#2025-162
Lakeland Farms – Pulte – Comprehensive Plan Amendment, Rezoning and Preliminary PUD/Plat Project Review for Planning and Zoning Commission

Meeting Date: December 17, 2025 continued from November 19, 2025

SITE PLAN
FOR
LAKELAND FARM

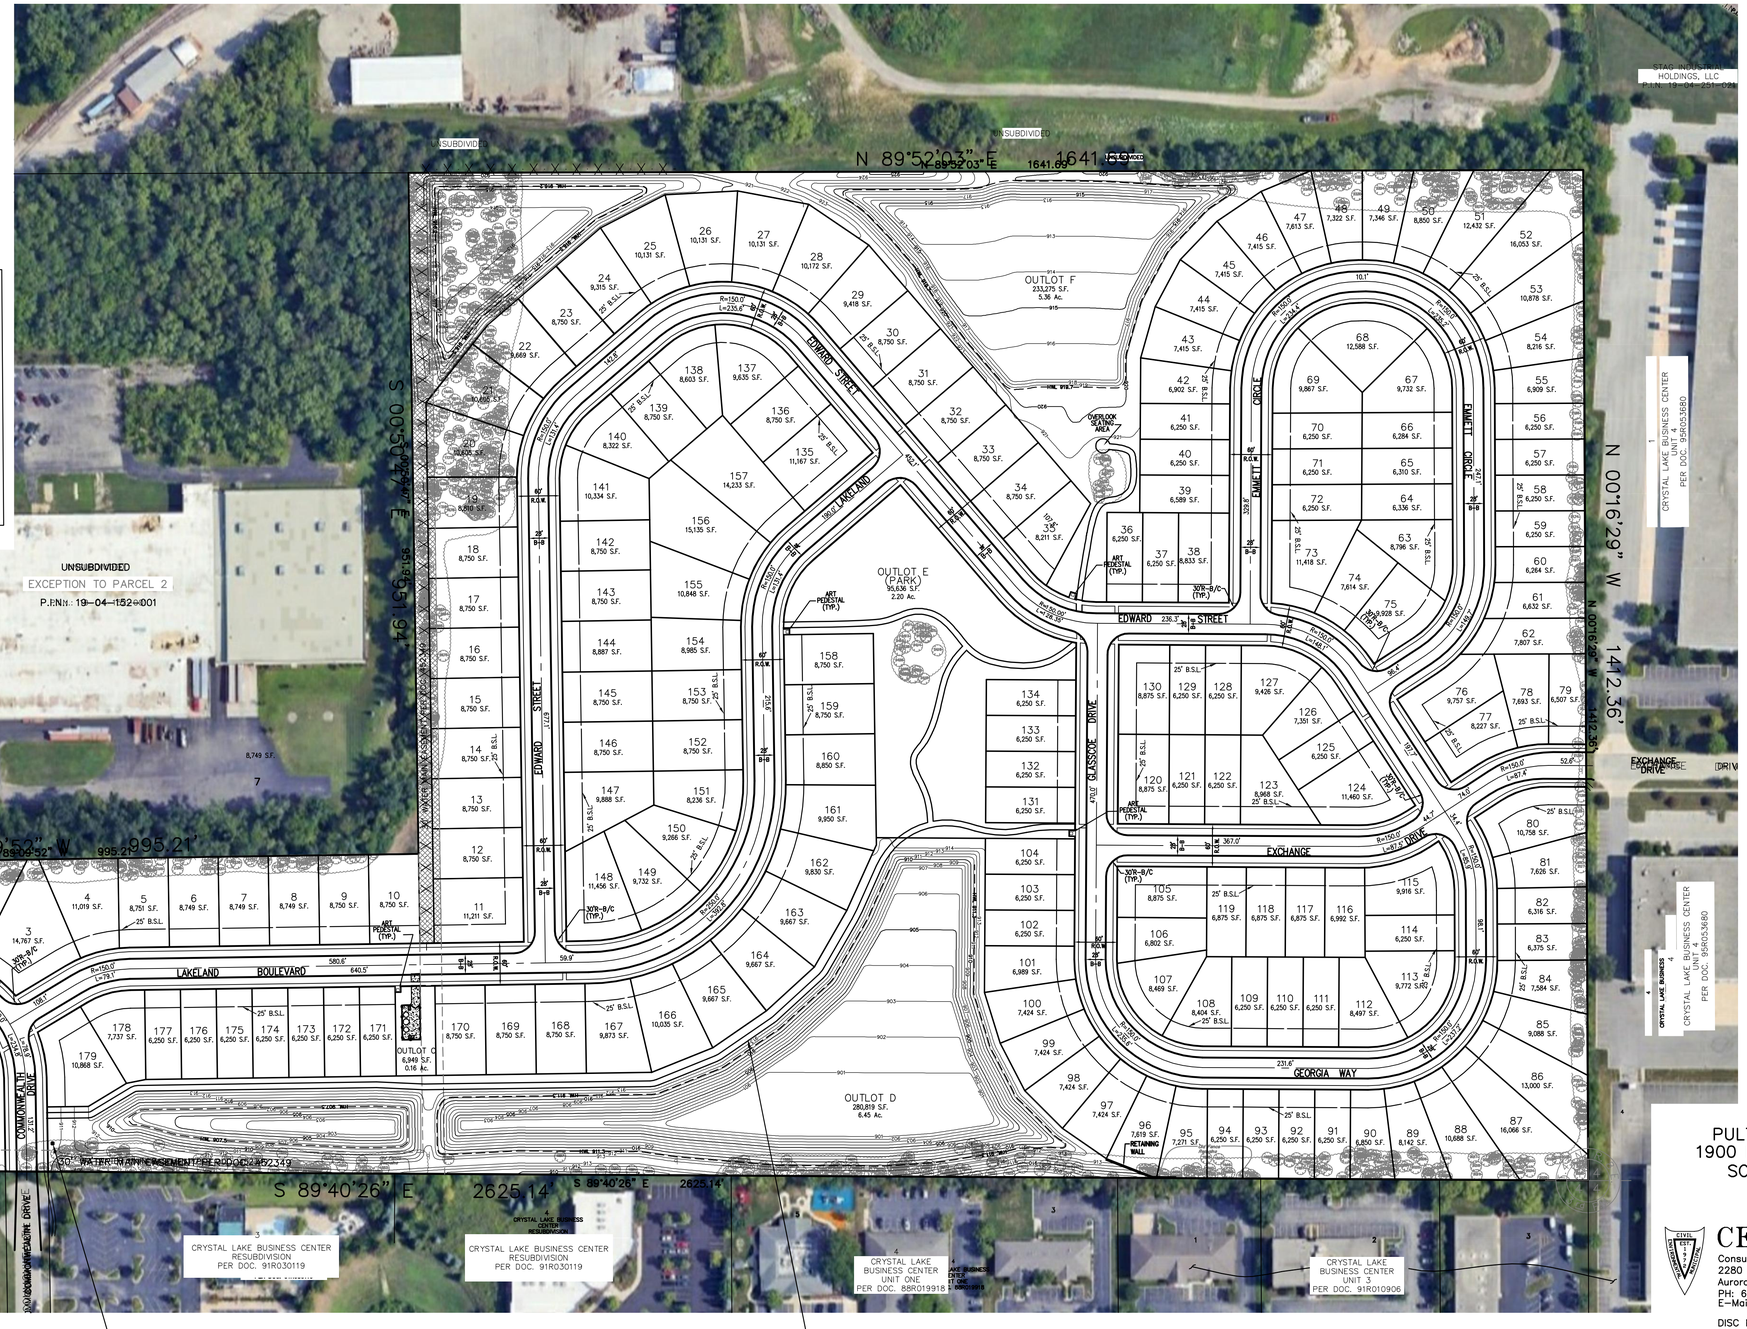
- The petitioner has made several revisions to the plans to address concerns:
- Three lots were moved from the park site to the north side of Edward Street to open the park up and create a larger area. This area now totals 2.2 acres. Additional usable open space has been identified in the other outlots.

- Meadows Series (smaller lots) were reduced by one lot and two Estate Series lots were added – totaling 179 lots.
- Art pedestals will be installed at four different locations in the community to create a visual cue as one would walk or drive through the site. The location of the art pedestals will be in the right-of-way to allow the City to work with artists for sculptures and maintain these areas.

- There was a discussion about a pedestrian path to the north property line. The City owns the adjacent property and utilizes it for various purposes. Due to this, City staff does not recommend a path going towards the property.

5. For the Final Planned Unit Development submittal, revise the various plans to match the revised site plan.
